DESIG	P	DRAWN BY	DART AEROSPACE LT HAWKESBURY, ONTARIO, CANADA	D
CHEC	KED /	APPROVED /	DRAWING NO.	REV. A
1	#	- AL	DSI 9349 sh	EET 1 OF 1
DATE			TITLE	SCALE
06.0	06.08.16		RIVET CHANGE	NTS
Α		06.08.16	NEW ISSUE

DART SERVICE INSTRUCTION

TO AMEND INSTALLATION INSTRUCTIONS IIN-D350-689 Rev.A
AND INSTRUCTIONS FOR CONTINUED AIRWORTHINESS ICA-D350-689 Rev.0
REF. CANADIAN STC: SH02-33
REF. FAA STC: SR01620NY

D330-669-041 Dudi High Back Seat Assembly

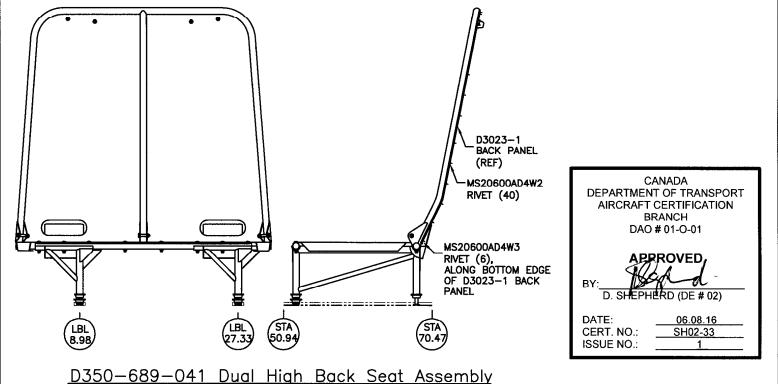
Some rivet lengths have changed, as indicated below, to ensure proper assembly of the D350-689-041 Dual High Back Seat Assembly. If installing replacement parts, it is acceptable to use longer rivets in other locations as required to ensure proper fastening. The parts list is revised as follows:

WAS:

QTY -041	Part Number	Description
Х	D350-689-041	DUAL HIGH BACK SEAT ASSEMBLY
46	MS20600AD4W2	RIVET

NOW:

QTY -041	Part Number	Description
Х	D350-689-041	DUAL HIGH BACK SEAT ASSEMBLY
40	MS20600AD4W2	RIVET
6	MS20600AD4W3	RIVET
